CITY OF LAFAYETTE  
DOWNTOWN LAFAYETTE SPECIFIC PLAN EIR

STATE CLEARINGHOUSE NUMBER: 2009062056

City of Lafayette | August 10, 2010

FIGURE 4.13-2  
EXISTING GEOMETRY AND TRAFFIC SIGNAL CONTROL

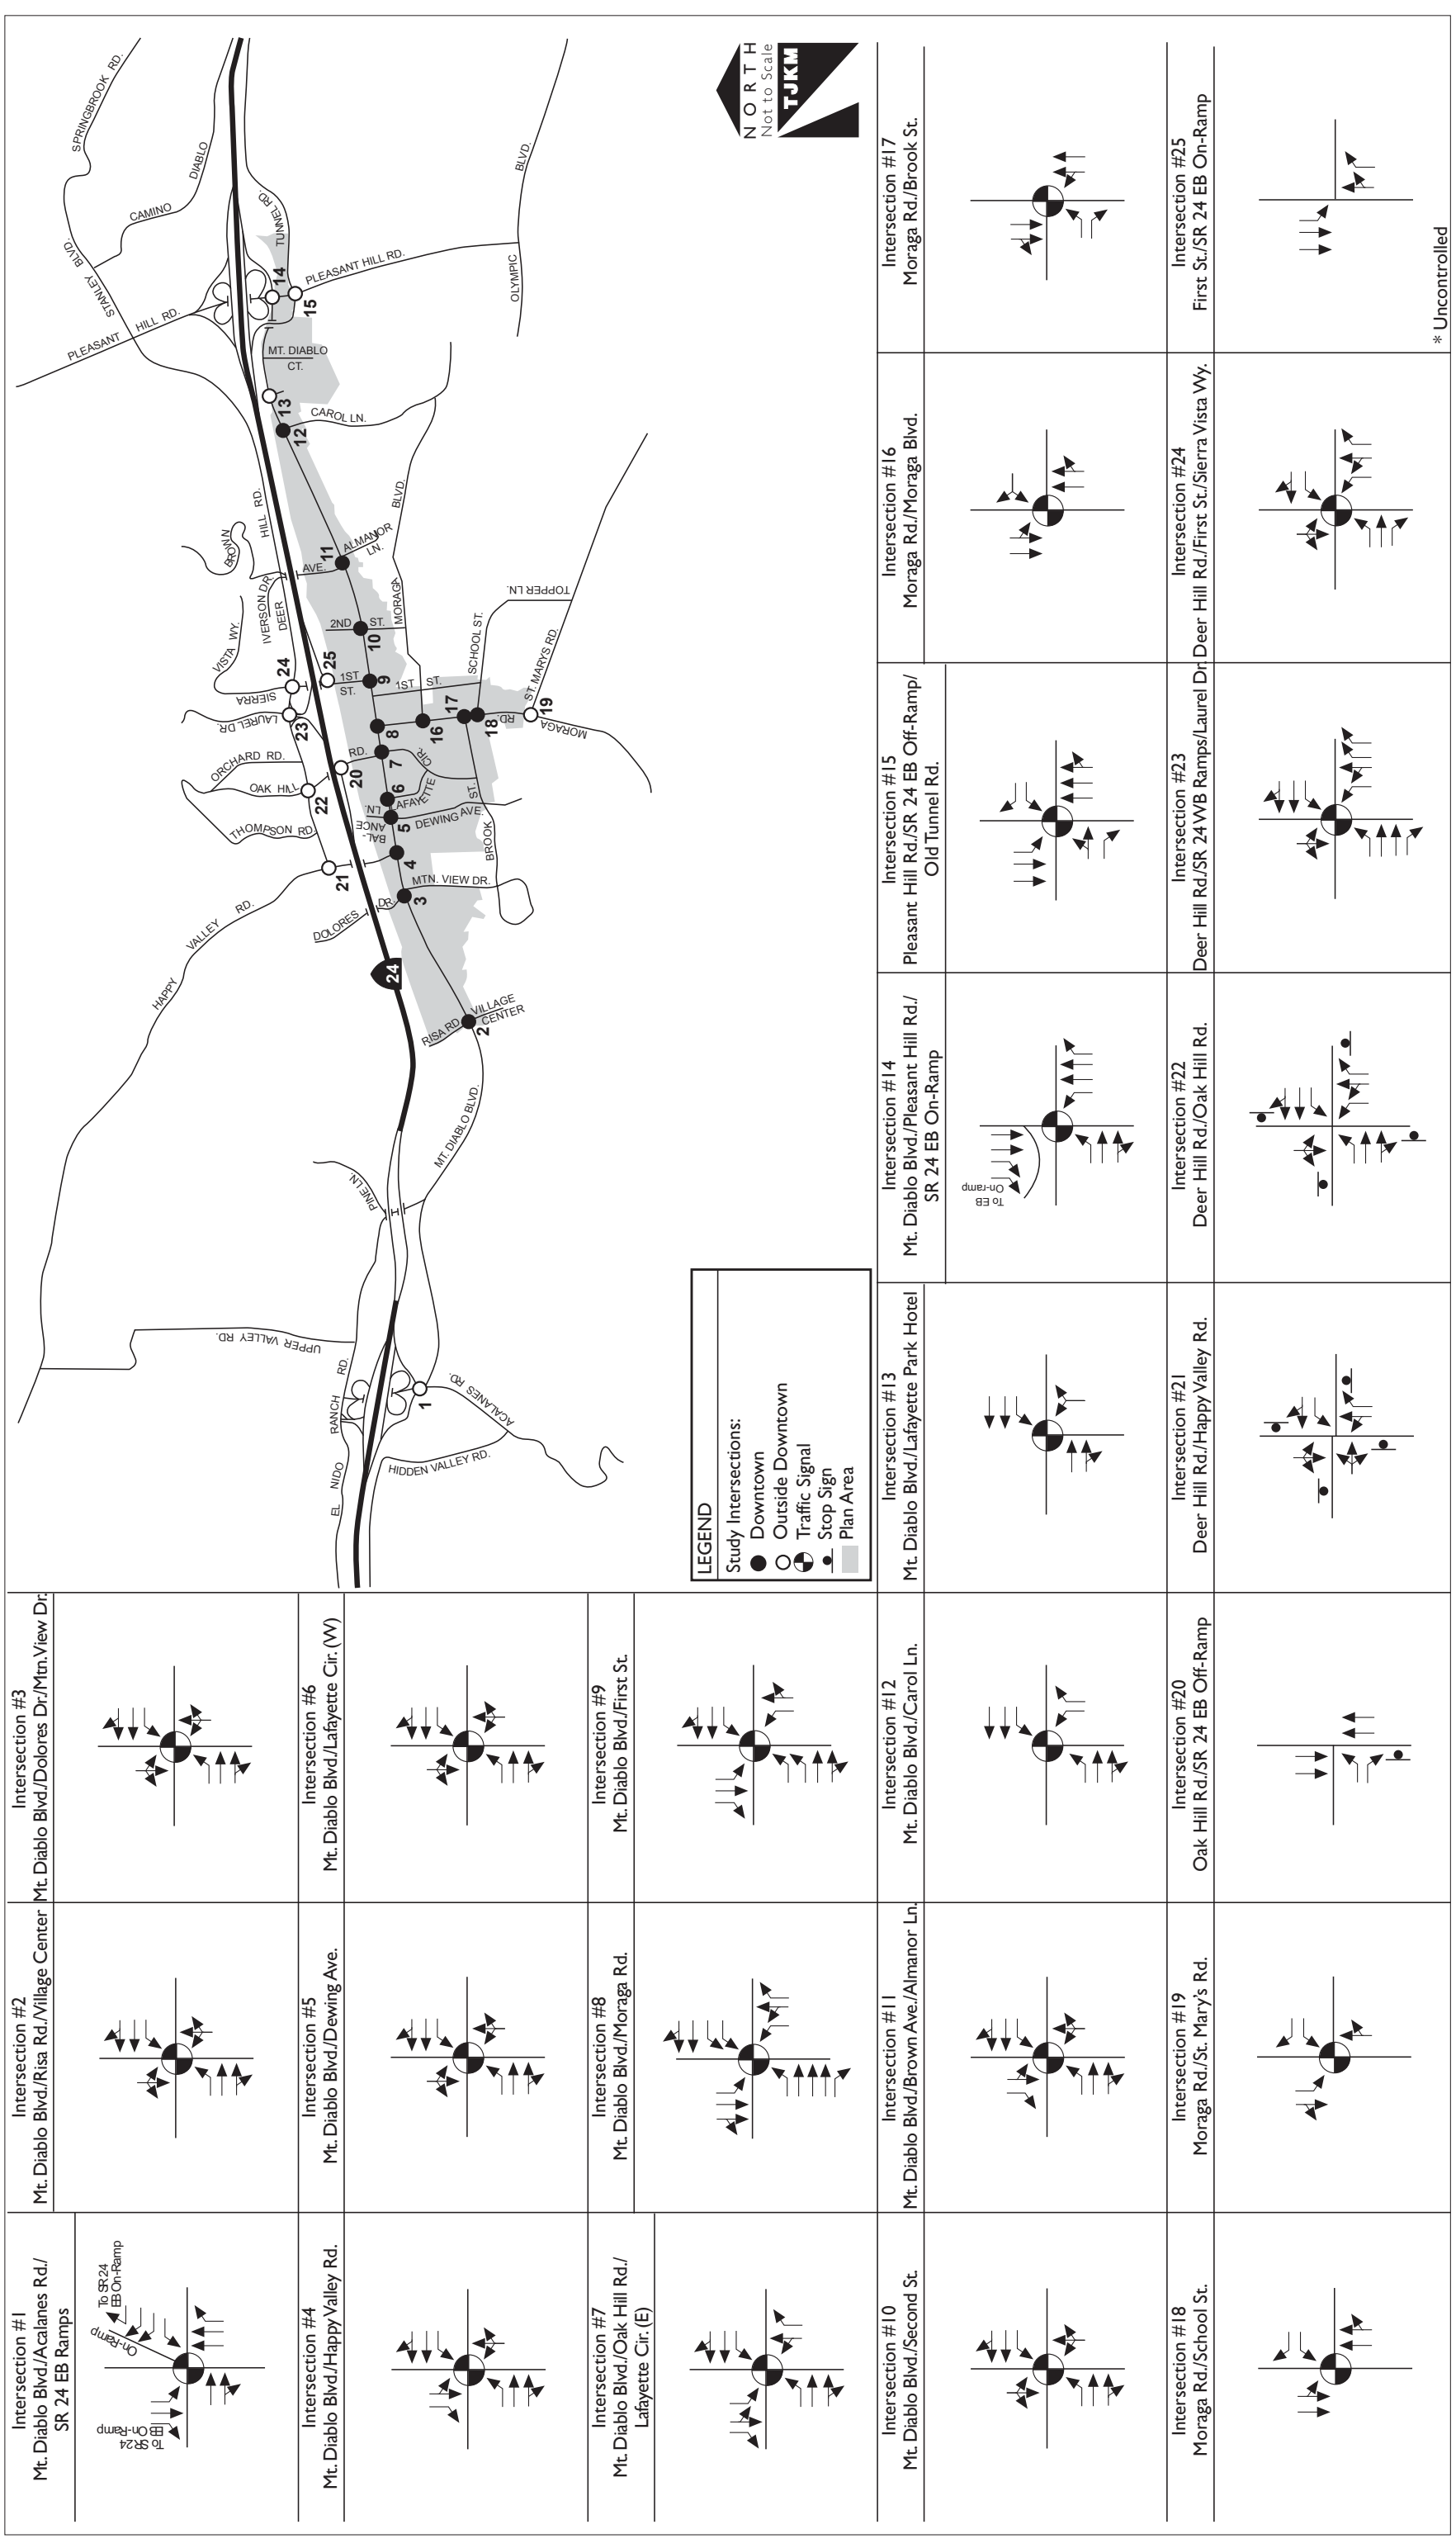
Figures 4.13-2, 4.13-3, and 4.13-4 on pages 4.13-11, 4.13-13, and 4.13-27, respectively, of the Draft EIR are hereby replaced with the figures on pages 3-47, 3-49, and 3-51.

FIGURE 4.13-5  
CUMULATIVE WITH SPECIFIC PLAN PROJECT PEAK HOUR TURNING MOVEMENT VOLUMES  
Source: TJKM

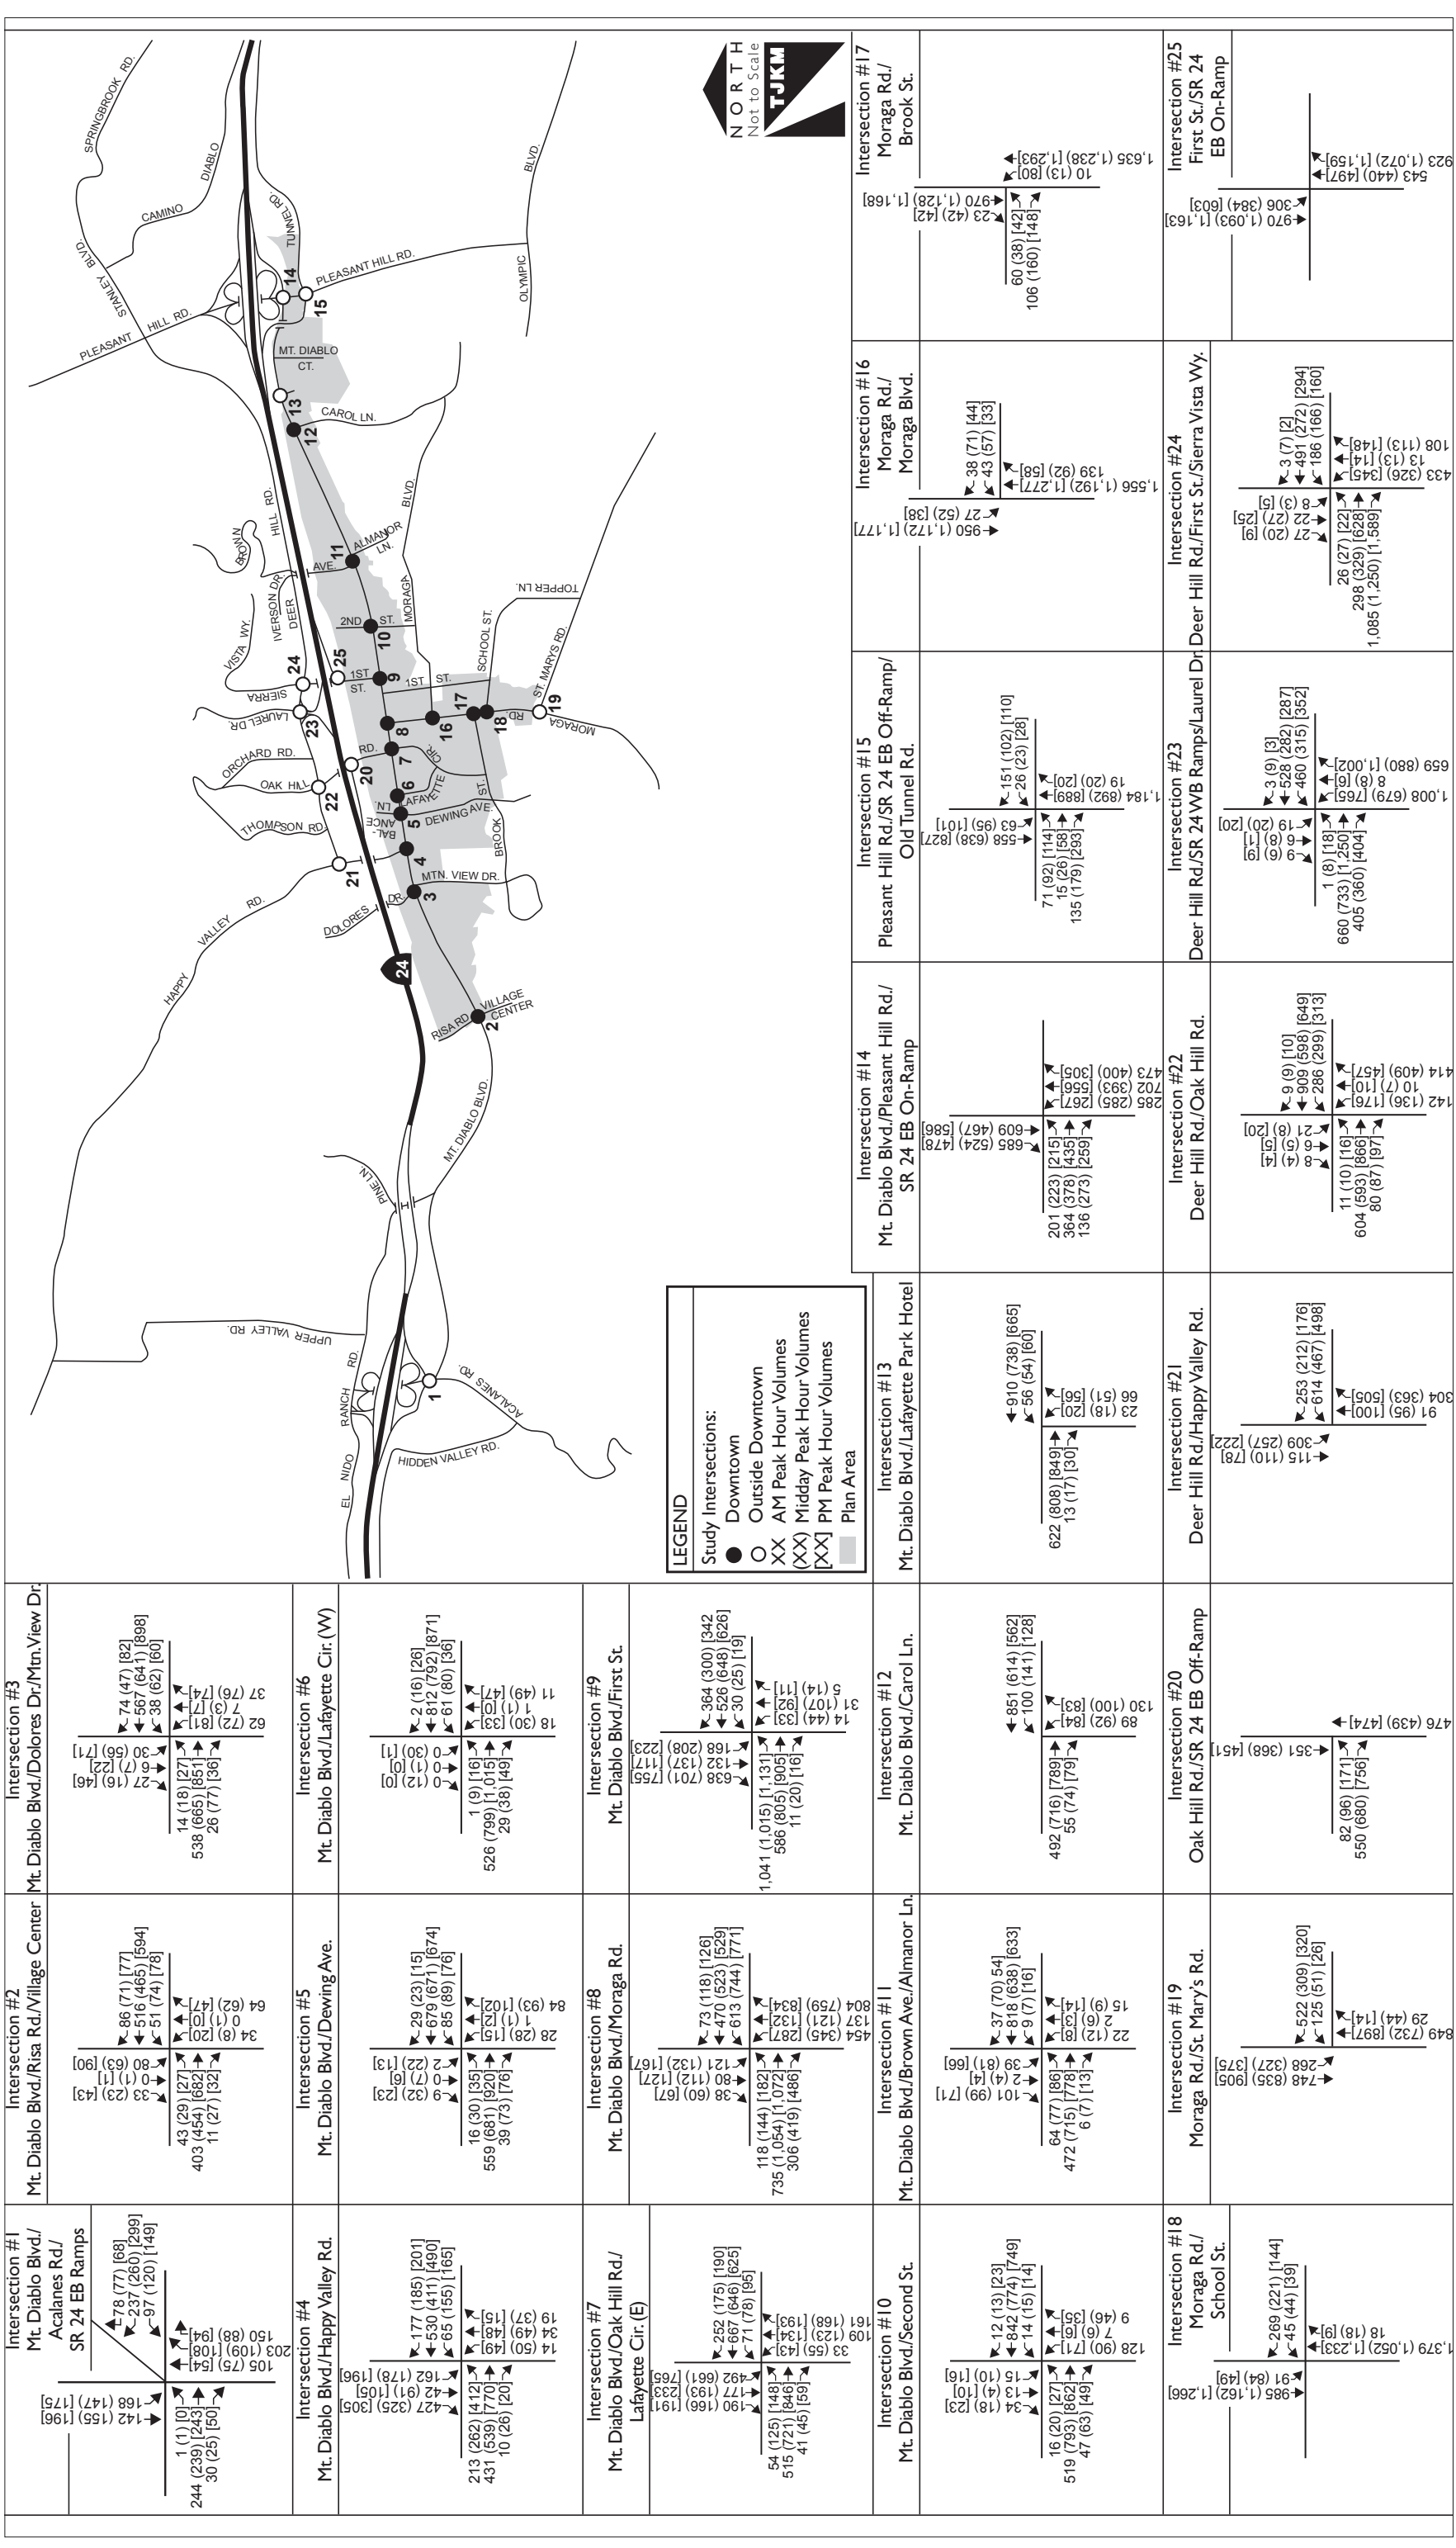
Figure 4.13-5 on page 4.13-33 of the Draft EIR is hereby replaced with the figure on page 3-55.

FIGURE 4.13-6

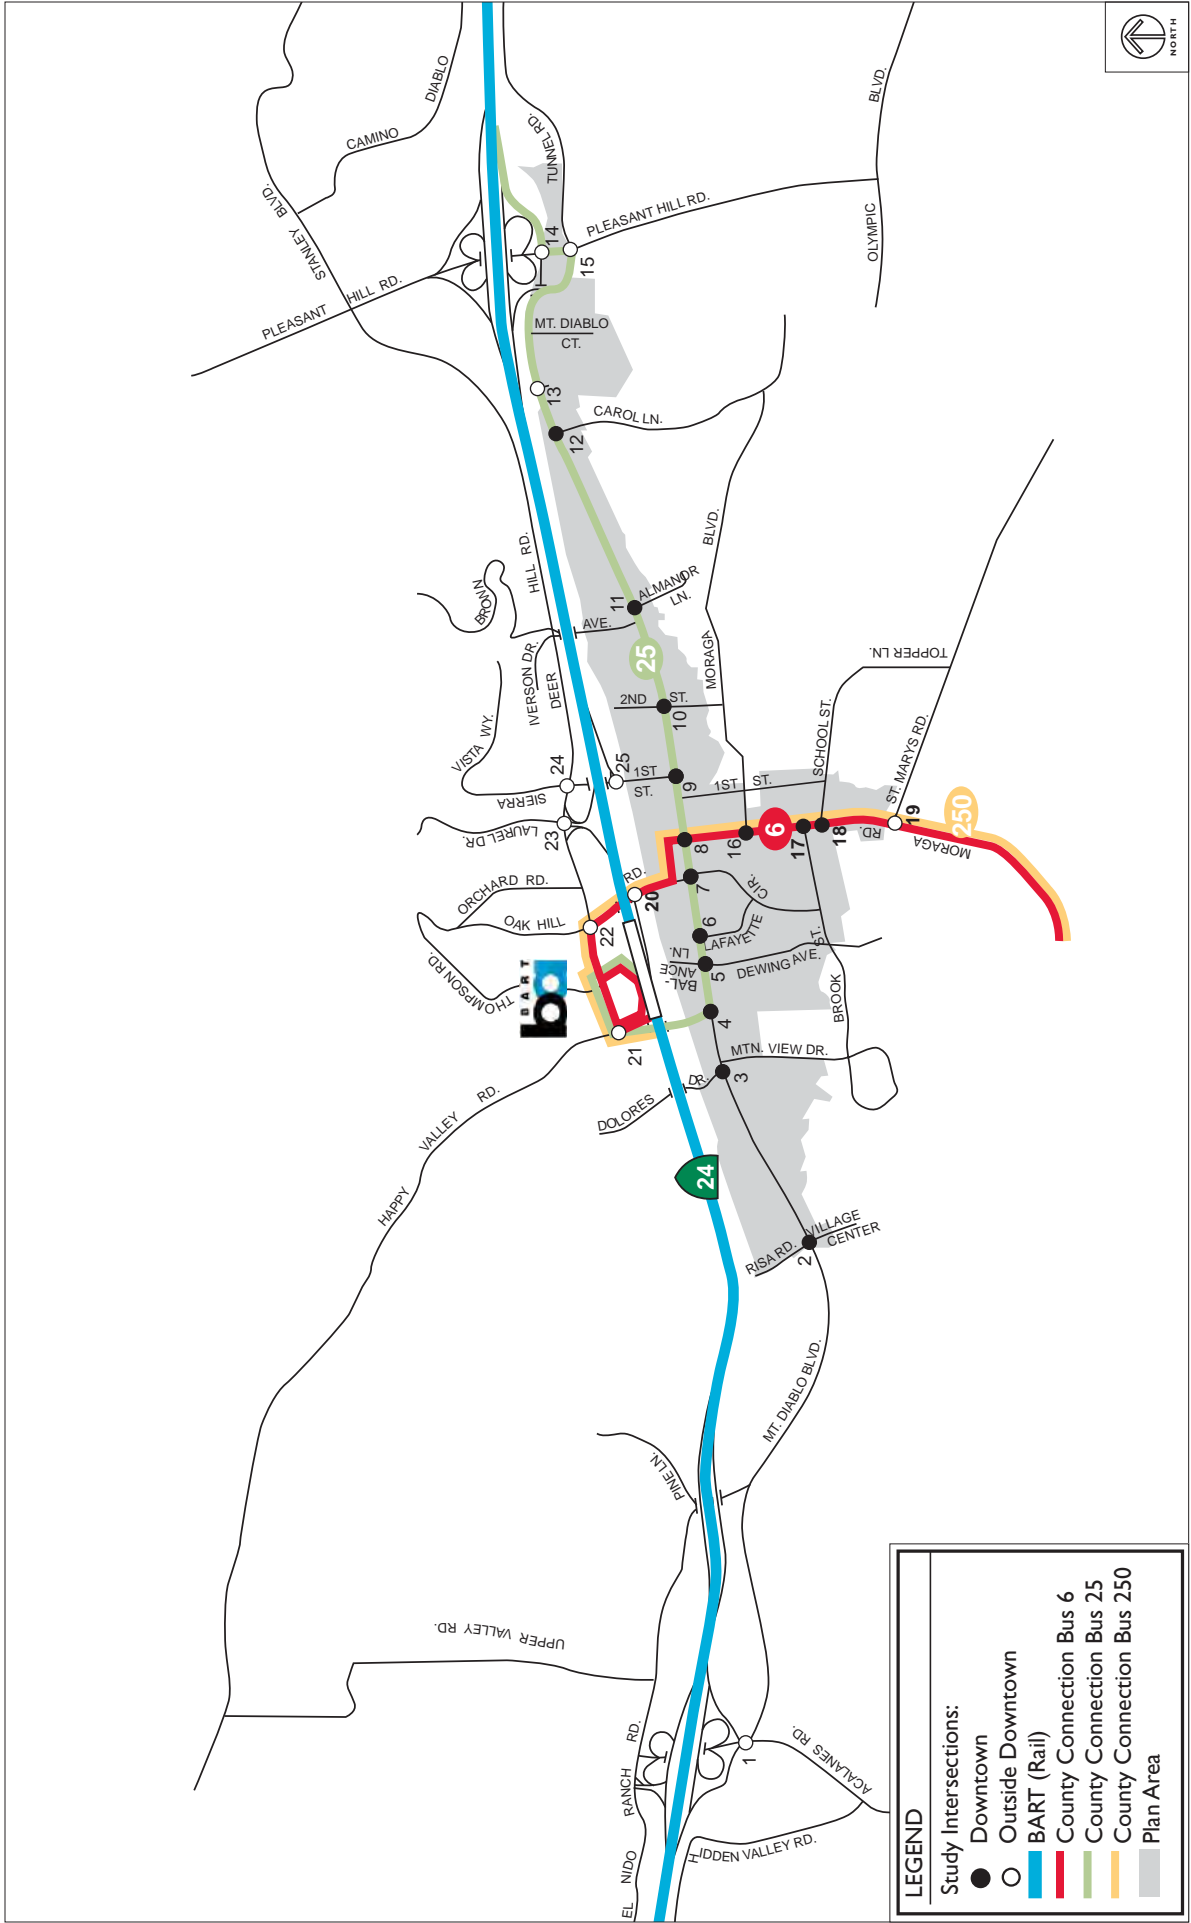
Figure 4.13-6 on page 4.13-58 of the Draft EIR is hereby replaced with the figure on the following page.
